ORDINARY MEETING OF COUNCIL

9 SEPTEMBER, 2014

ITEM-4	NORTHCONNEX - ENVIRONMENTAL IMPACT STATEMENT
THEME:	Balanced Urban Growth
OUTCOME:	6 Safe, convenient and accessible transport options that enable movement through and within our Shire.
STRATEGY:	6.1 Facilitate the provision of integrated transport alternatives that link residents to their home, places of work and services and facilities.
GROUP:	STRATEGIC PLANNING
AUTHOR:	MANAGER – COMMUNITY PLANNING & SPECIAL INFRASTRUCTURE PROJECTS MICHAEL LATHLEAN
RESPONSIBLE OFFICER:	GROUP MANAGER – STRATEGIC PLANNING MICHAEL EDGAR

Figure 3: M7 to F3 (now M1) corridor (source: SKM Study 2004)

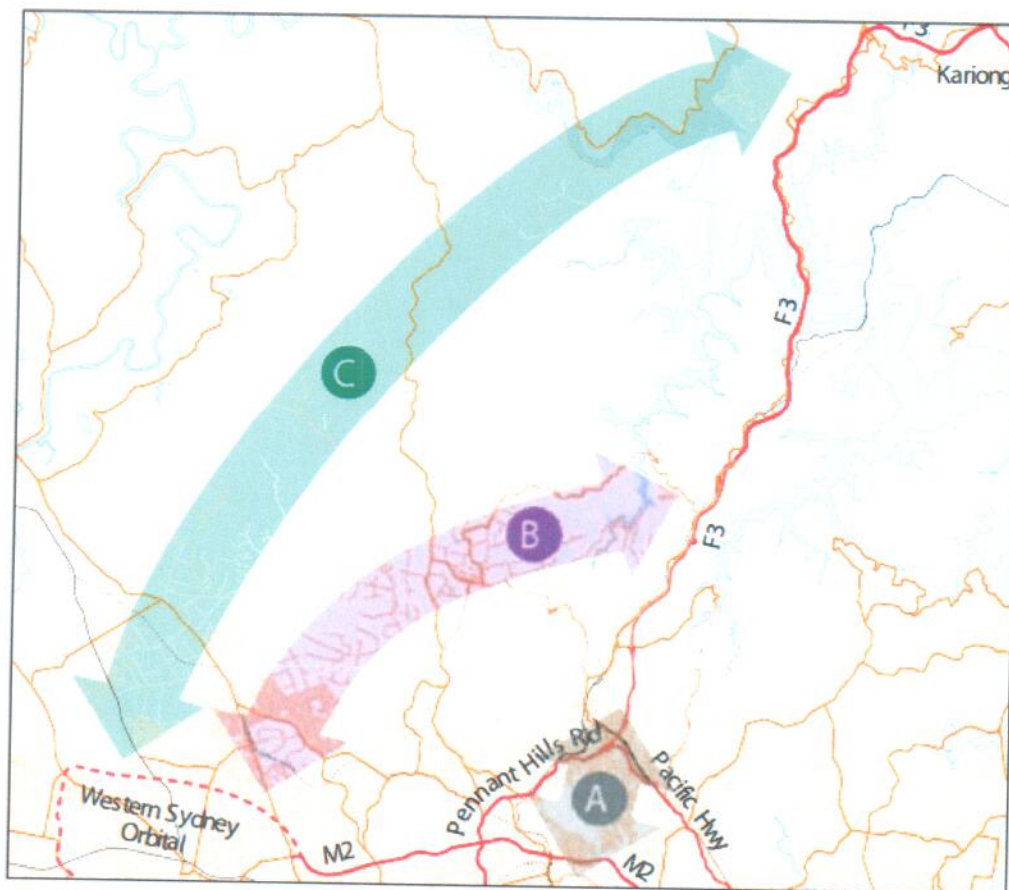
A key infrastructure requirement identified within the Direction is a connection between the M7 and F3 (now M1). The Direction sets out that the preferred option of Council be a westerly connection between M7 at Dean Park and F3 at Kariong. This is the former Type C Option as identified in the 2004 F3 to Sydney Orbital Link Study (Figure 3).

Council will need to continue to lobby government to commence corridor protection and planning of the Type C Option as a long term strategic transport need. Planning for the Type C Corridor is consistent with the outcomes of the 2007 Pearlman Review of the F3 to M7 Corridor Selection process. The review recommended that whilst a Type A tunnel would provide relief from congestion on Pennant Hills Road in the medium term, planning for a Type C Corridor should commence to cater for long term strategic transport demand.
